Doug Albright
Actuation Test Equipment Company
3393 Eddie Road
Winnebago, ILL 61088

May 14, 2007

Robert N. Jones
Robert.N.Jones@USACE.Army.Mil

Figure 1 GDACS 3-D cam setup screen with Deadband input feature

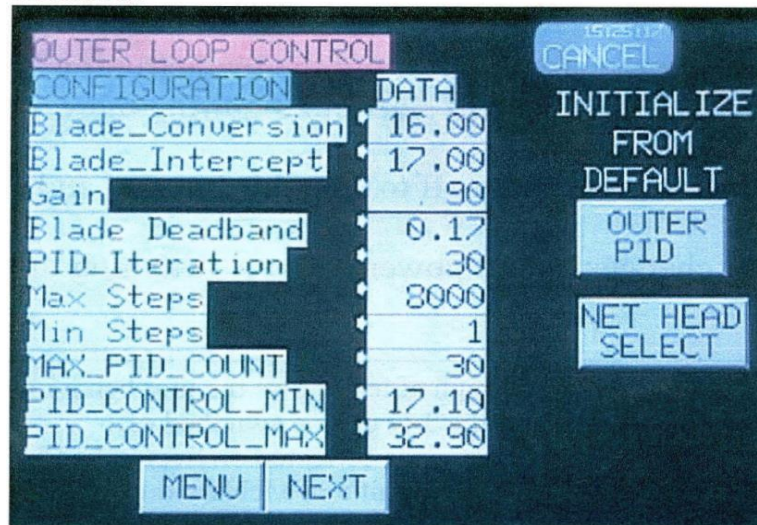
The image at left is the setup screen from a GDACS 3-D cam. These are input parameters set by the operators. Note the 6th item down the list: "Blade Deadband." At McNary, this value was set at 1.0 degrees.

5. What is the specified accuracy in the contract to ACSI for the GDACS 3-D cams that are in place now? Is there an accuracy specification?
6. Is there a feature on the HDC/ACSI 3-D cam and blade control system that allows programming in an added deadband for blade position? (See figure 1 if their answer is no.)

Figure 2 Baseline cam profile of GDACS 3-D cam

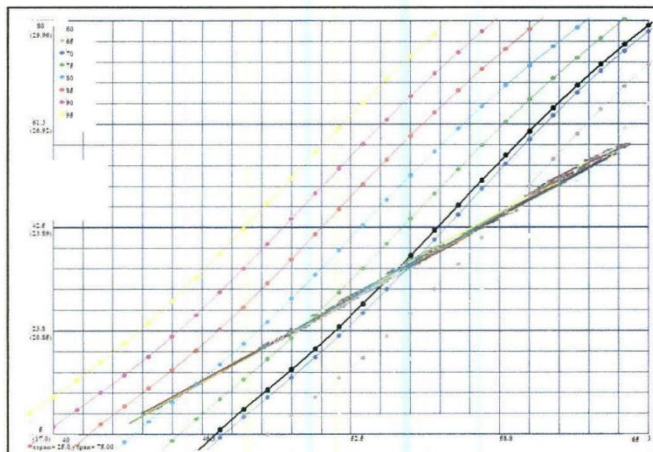
The graph at left shows the unit behavior when the 3-D cam is switched off. This data was collected on September 8, 2005 from Unit 5 at McNary during an overnight data collection run.

The blades should be tracing one of, or a similar curve located between the colored head lines.

This data shows the baseline cam profile of the mechanical cam without the added input from the GDACS 3-D cam computer.

Industry standards set out in IEEE Std-125 call for blade positioning accuracies of 1.0 percent and response time of 0.2 seconds. The 1.0-degree deadband at McNary is 13 times this allowance. The 35 second deadtime is 175 times greater than the industry standard for time-response performance.

Figure 3 Operating Efficiency envelope of a Kaplan turbine

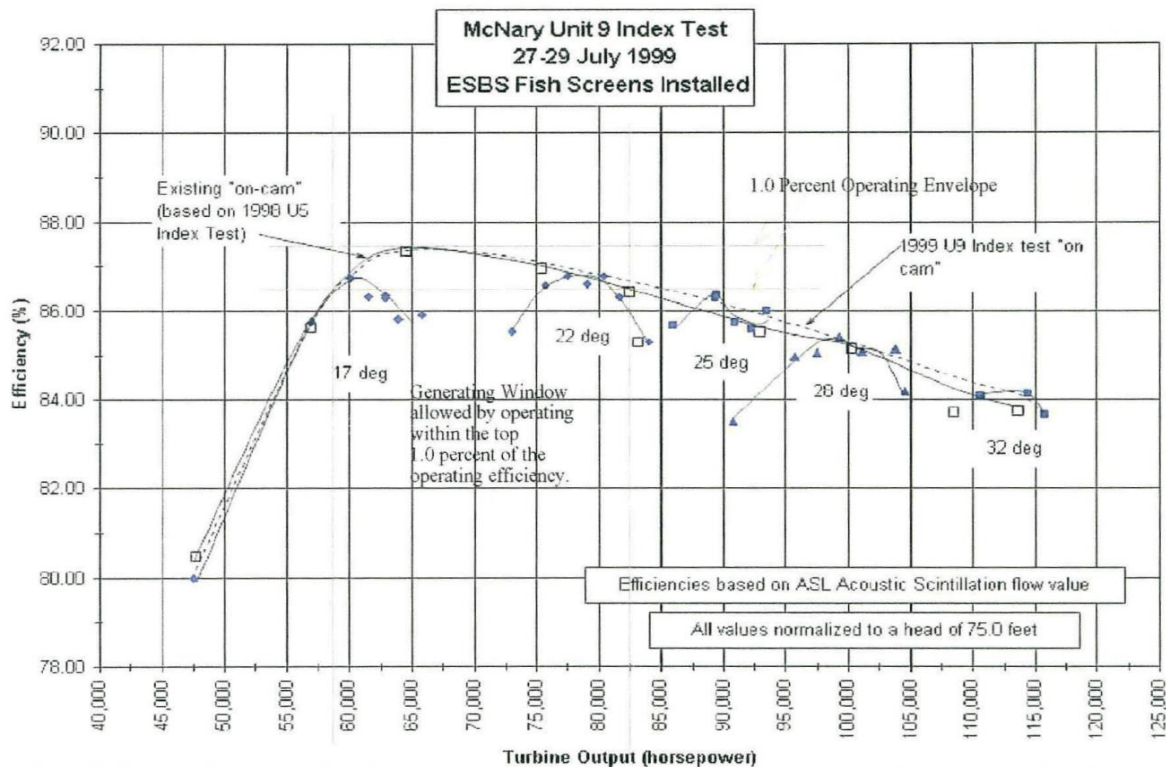
Figure 3 illustrates the operating efficiency envelope of a Kaplan turbine resulting from an index test, with the top 1.0 percent delineated by two horizontal lines.

The top line is tangent with the absolute peak efficiency, and the bottom line is 1.0 percent below it.

During certain periods of the year when moderately endangered fish are migrating, the Federal Court restricts operation to within this top 1.0 percent of this efficiency envelope.

From the data in Figure 3, the operating window is restricted to between 58,670 and 82,500 Horsepower.

Figure 4 Effect of Blade Error on Turbine Efficiency

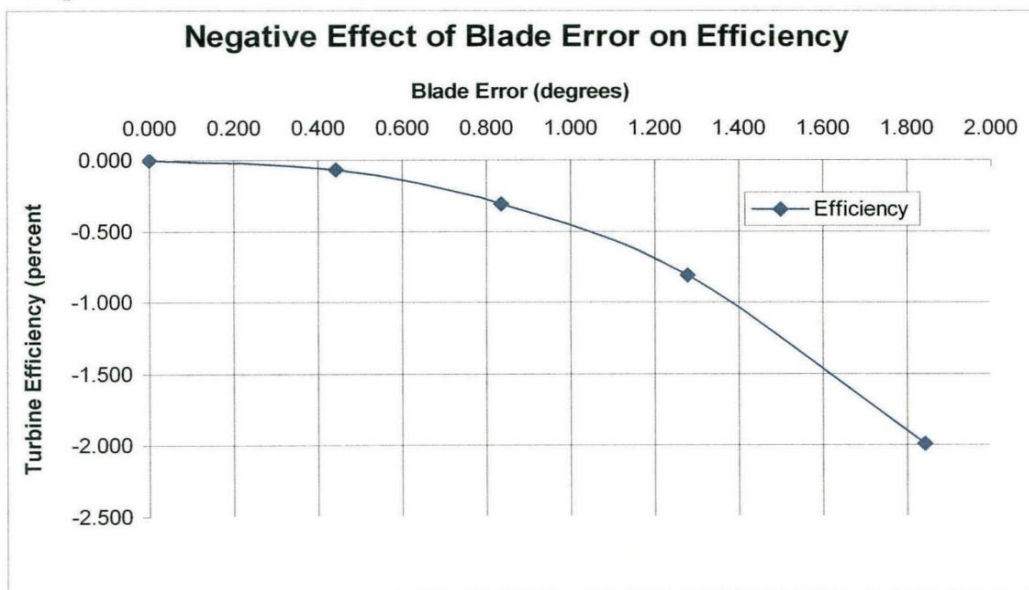
Figure 4 shows the effect of blade error on turbine efficiency. This data was gleaned from HDC's own turbine index test data, and is representative of typical large Kaplan turbine performance.

Note that with a 1.0 degree blade error, the efficiency decreases about 0.5 percent.

This is not the only source of lost efficiency; it is just one factor that is added into the error budget that must be within the 1.0 percent operating envelope.

HDC's arbitrary deviation from industry standards to save a few bucks in deference to the Court's order is disingenuous, and contrary to USACE's compliance with the Court's order.

Appendix 1. Analysis of McNary Unit 9 data

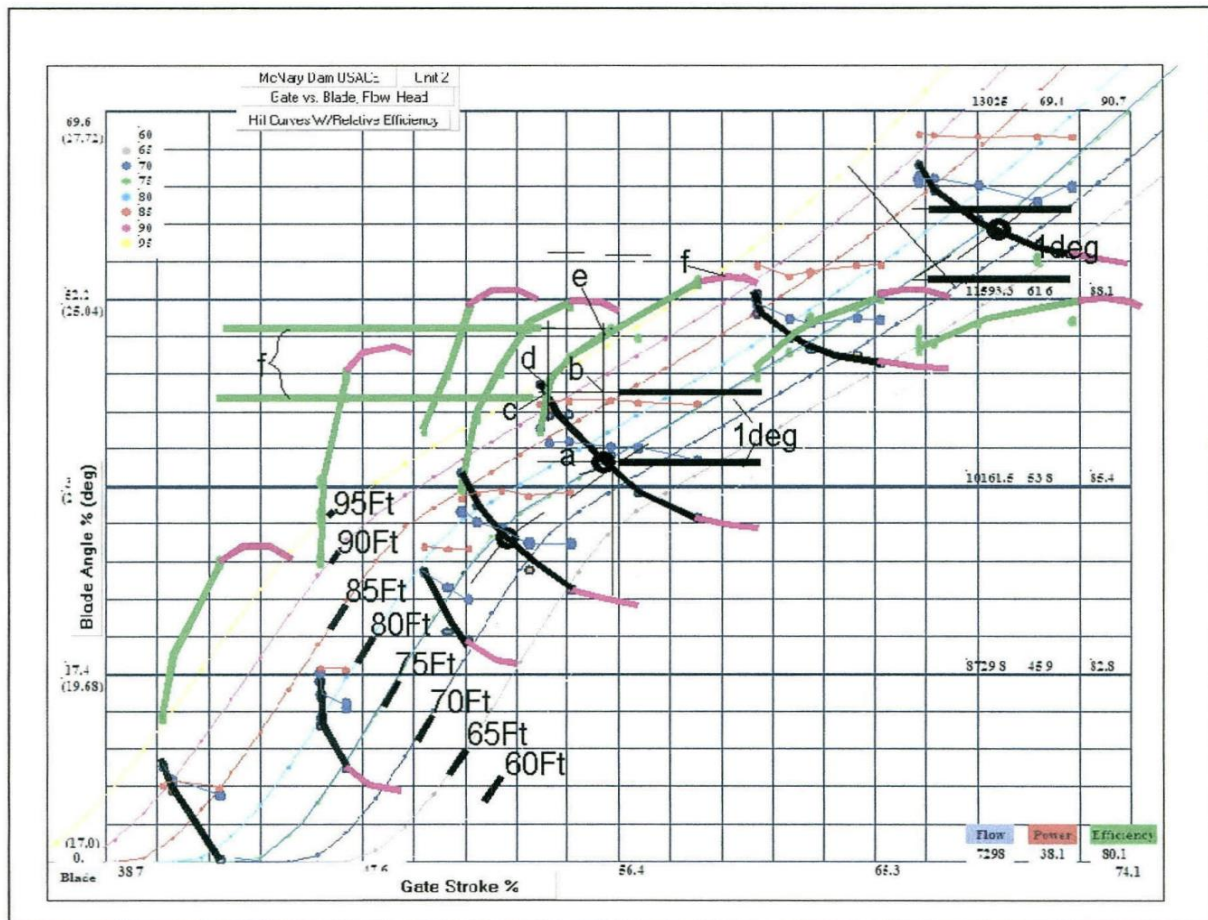
To show the impact of a 1.0-degree deadband, graphic measurements are used to demonstrate the efficiency loss, and resulting cost of this intentional misalignment of the blades.

Point “a” is the Ideal Cam position from the GDACS 3-D cam running at

53 MW at 75-foot head. Assuming this is the actual efficiency peak of the machine (due to other calibration problems with the unit, it’s not), project a line up a distance of 1.0 degree to point “b,” – this is the deadband error programmed into all of the GDACS 3-D cams at McNary.

The unit is still operating at the same power level as point “a.” The constant generation curve shows where 53MW will occur at “c,” the gate-blade operating point for 53 MW with a 1.0-degree blade error.

Now project two vertical lines up to meet the efficiency contour at "d" & "e." The distance between "d" & "e" is the lost efficiency from operating at the same power level with a 1-degree blade angle error - if the Ideal Blade position at "a" were truly the optimum point.

But it isn't; the actual efficiency peak indicated by the index test data we collected is somewhere around "f," the extrapolated point that was projected beyond our test range. The actual lost efficiency is the vertical distance from "d" to "f."

Using the same graphical method, the distance from "d" to "f" is measured to be a loss of about 1.5 percent efficiency. By the 1.0 percent Injunctive Relief edict, when operation is restricted to protect endangered species migrating downriver, this unit should not be operated at all.

Figure 6 Rectangular Spiral motion of GDACS 3-D cam.

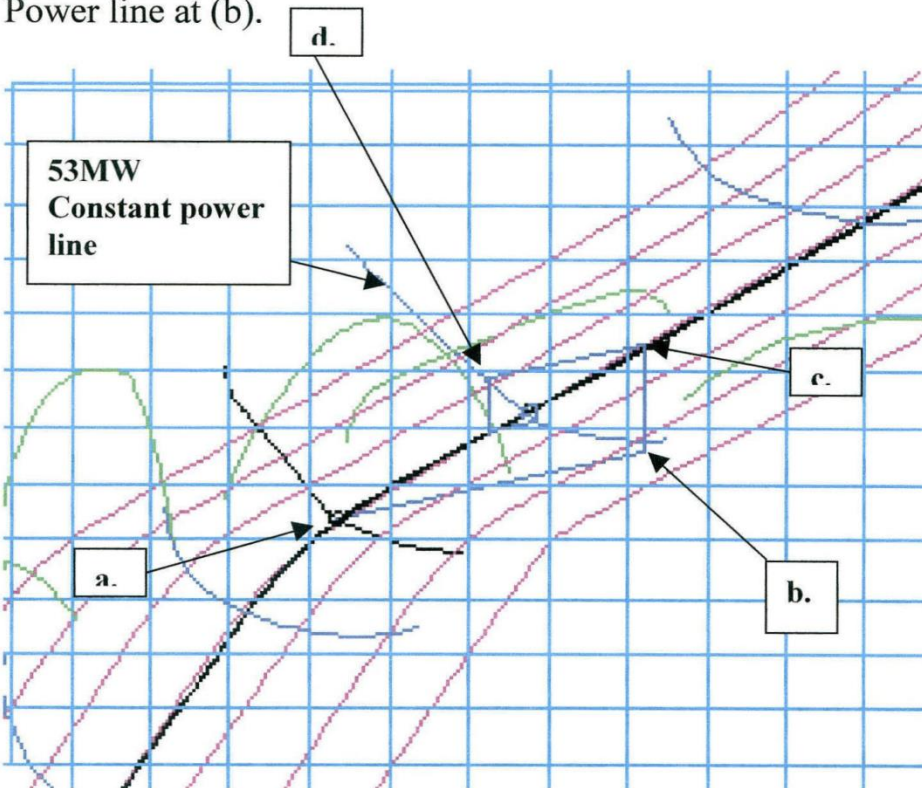
1.) When a large upward SetPoint change is made in power; starting at (a.) on figure 6, the governor's speed motor is activated to raise the SetPoint by the GDACS control system. The gates open rapidly to get the power output up to the new SetPoint level. For this example it's the 53MW Constant Power line at (b).

The increase in power output is sensed by the GDACS control system, which will continue to open the gates until the generation SetPoint demand is satisfied at (b).

Due to the 35-second deadtime in the blade control system, the blades move only in response to the profile of the linear rise mechanical cam mounted on the gate restoring shaft, indicated by the line from (a) to (b). During this time, the stepper motor in the GDACS 3-D cam that provides the rest of the required motion to get to the "Ideal Blade" angle does not move. This causes the gates to overshoot, moving farther than they would have had the blade

About 35 seconds later, the blade controller wakes up, takes note of the change in gate position, computes the new Ideal Blade angle, and then moves the stepping motor to complete the blade motion to the new Ideal Blade position for 75 ft head relative to gate position at (c.), as dictated by the 3-D cam algorithm and cam surface lookup table.

When the blades move to this new, steeper position, power output increases significantly, exceeding the deadband set for the power level controller in the GDACS, and then the closed loop on power in the GDACS pulls the gates closed to get power back to the SetPoint.

After another deadtime in the GDACS load feedback, the speed motor is moved again to lower power back down to the load SetPoint at (d.). Again, the blades do not move in unison with the gates to track the cam line because the 35-second deadtime is in effect.

This motion continues until the blades are within the 1-degree deadband programmed into the Panel Mate touch screen control panel.

To avoid this “rectangular spiral,” (or to better characterize the impact this misalignment would have on any fish passing through the turbine during this sequence, we could call it a “rectangular death spiral”) the operators change the generation SetPoint very slowly so the blade control system can keep up.
